Re: U.S. Patent No. 6,819,199 B2; Issued: November 16, 2004  
(from Appl. No. 09/892,755; Filed: June 28, 2001)  
For: **Balun Transformer with Means for Reducing a Physical Dimension  
Thereof**  
Inventors: Burns *et al.*  
Our Ref: 1875.0350001

**Request for Certificate of Correction  
Under 37 C.F.R. § 1.322 and 1.323**

## UNITED STATES PATENT AND TRADEMARK OFFICE CERTIFICATE OF CORRECTION

**Amendment and Reply Under 37 C.F.R. § 1.111**

FIG. 8

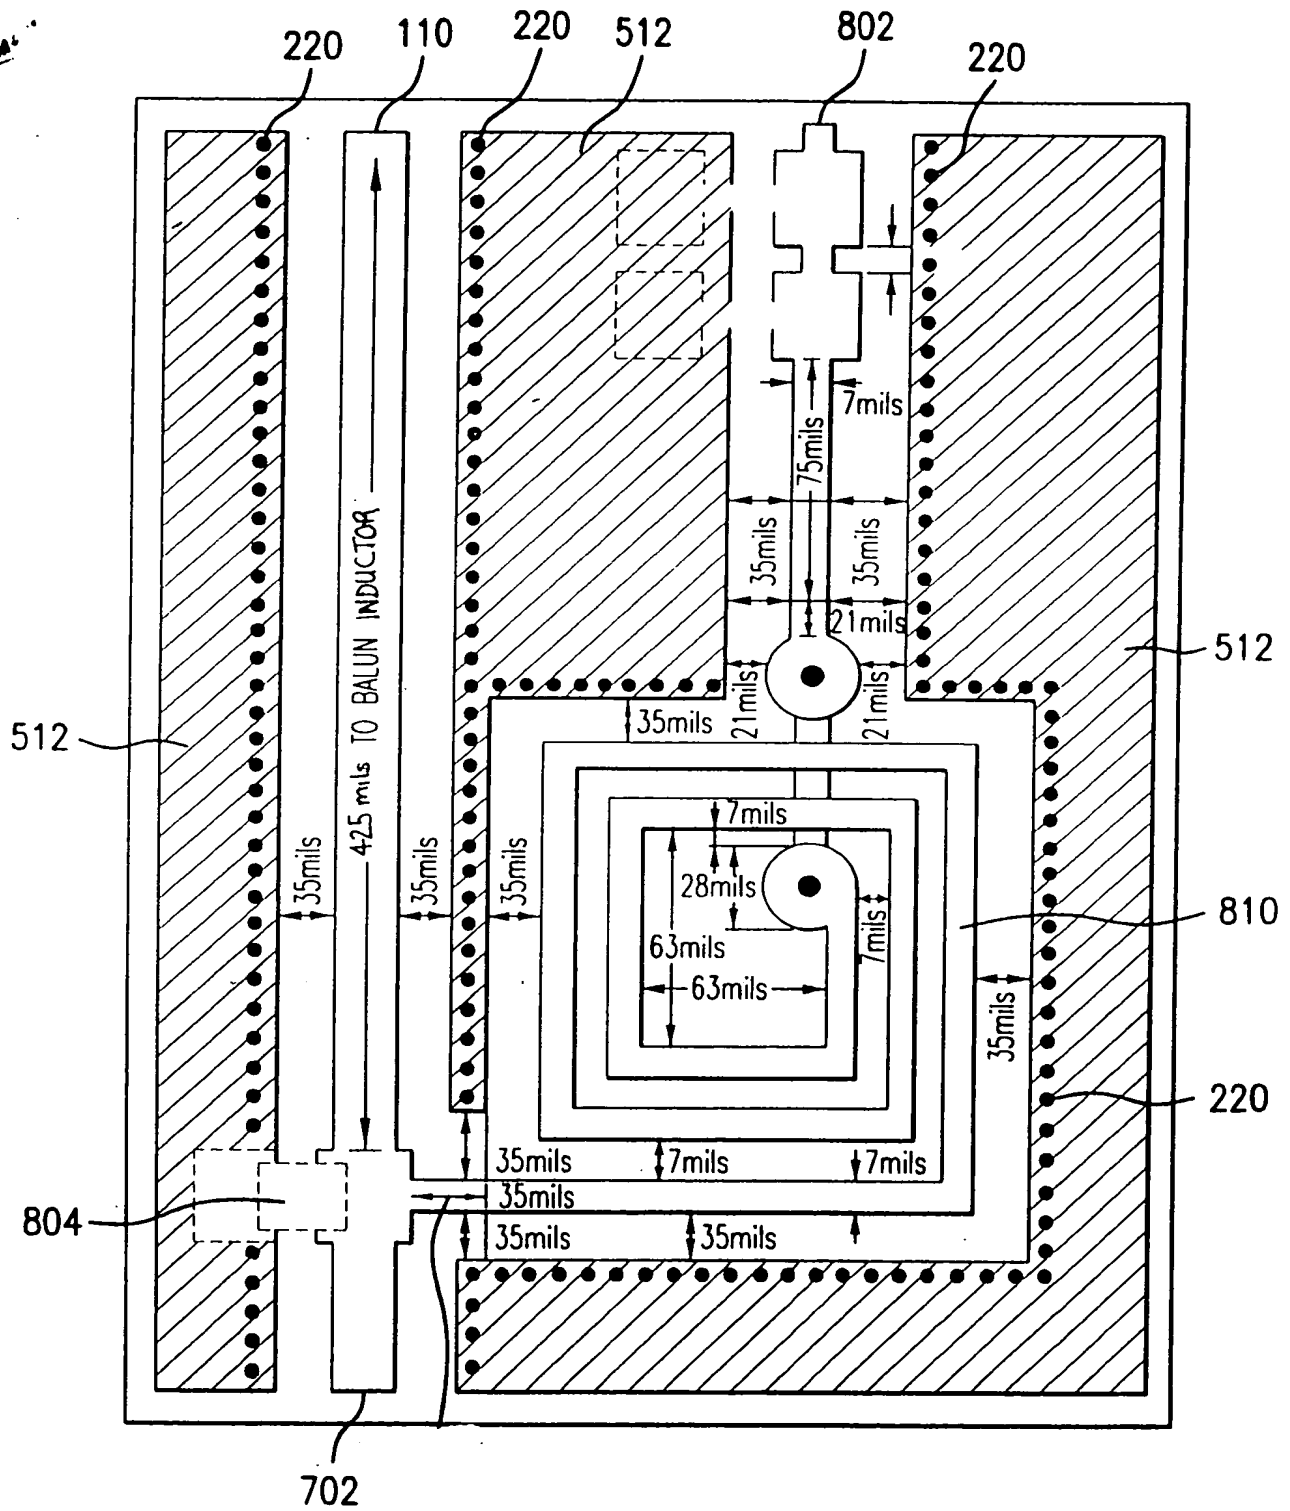
In the Office Action on page 2, the Examiner objected to the specification because of various informalities. Specifically, the Examiner objected to replacement paragraph [0066] because "it is unclear whether the reference to '425 mils ...' is appropriate since the description of this paragraph pertains to 'Fig. 8' while '425 mils' limitation appears to relate to the 'fig. 7' description." Applicants submit that Fig. 8 on formal drawing sheet 13 contains typographical errors in the label "432 mils TO BALUN

INDICATOR." In Fig. 8, as originally filed, this label correctly stated "425 mils to BALUN INDUCTOR." Applicants have amended Fig. 8 on drawing sheet 13 to reflect the label used in originally filed Fig. 8. Applicants submit that this amendment addresses the informalities raised by the Examiner.

On page 2 the Examiner objected to Fig. 8 because the label "'BALUN INDICATOR' should correctly be -- BALUN INDUCTOR--." As discussed above, Applicants have amended Fig. 8 as suggested by the Examiner.

FIG. 7

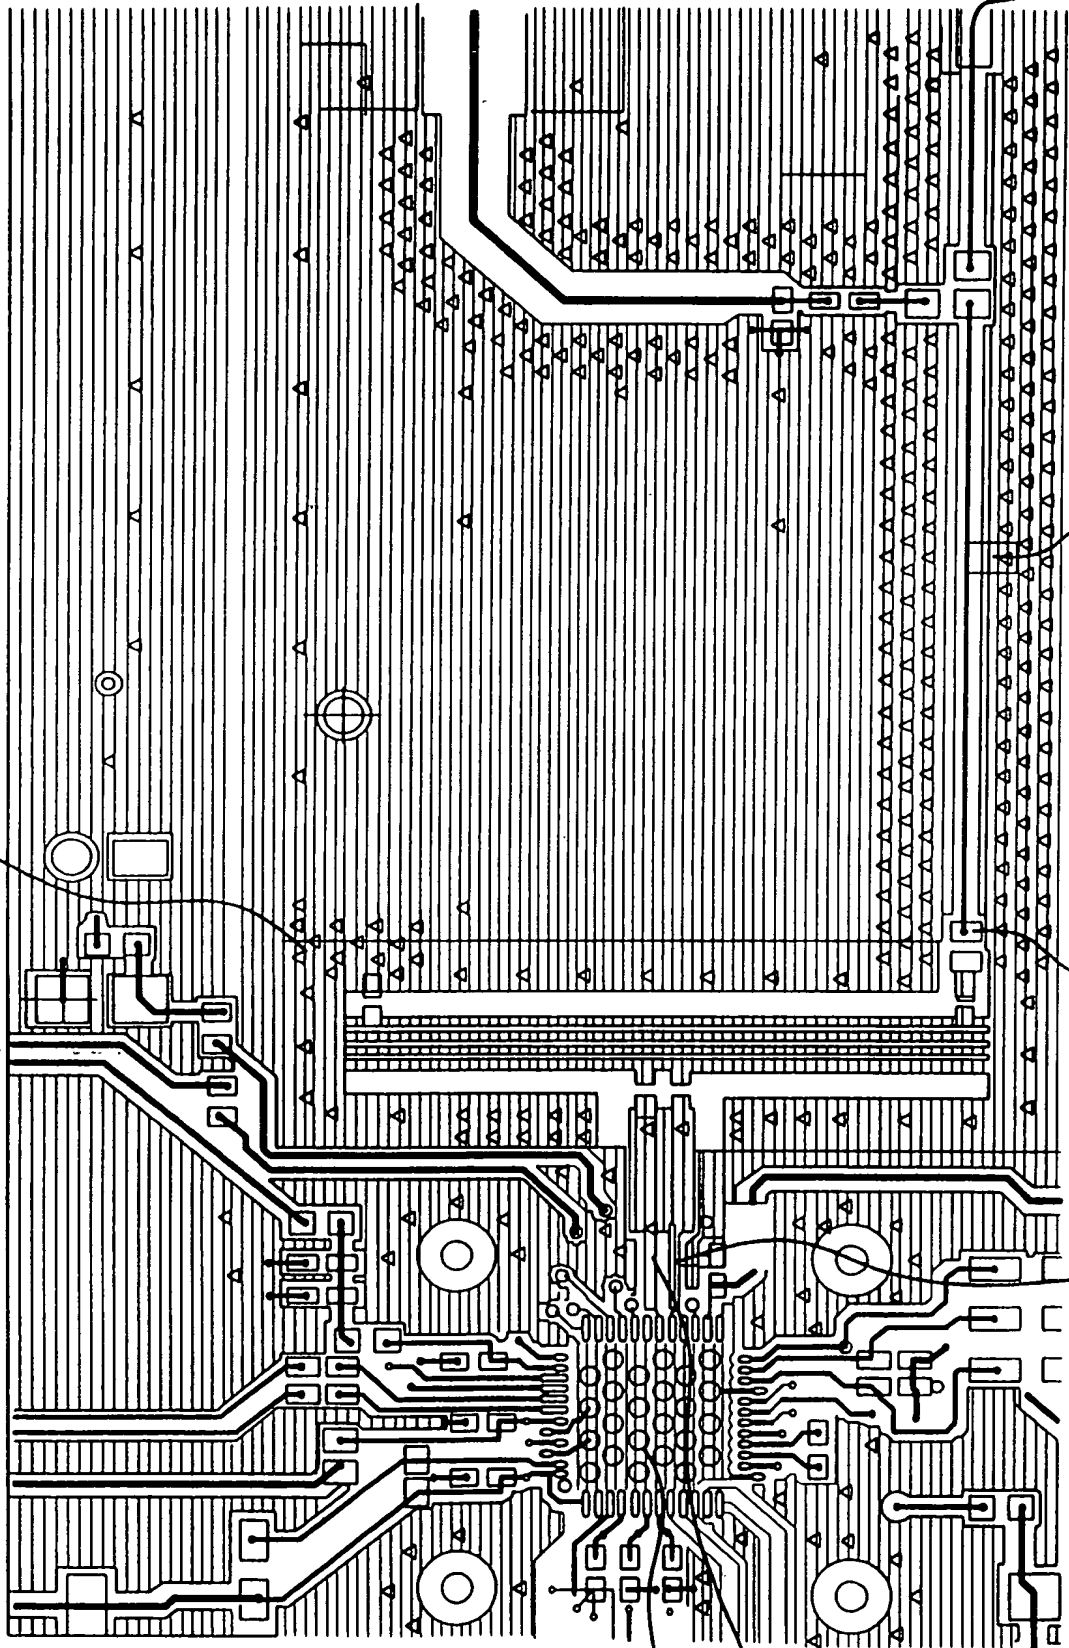
Applicants have amended Fig. 7 to replace the label "(.425)" with the label "425 mils" to provide consistency with the specification.
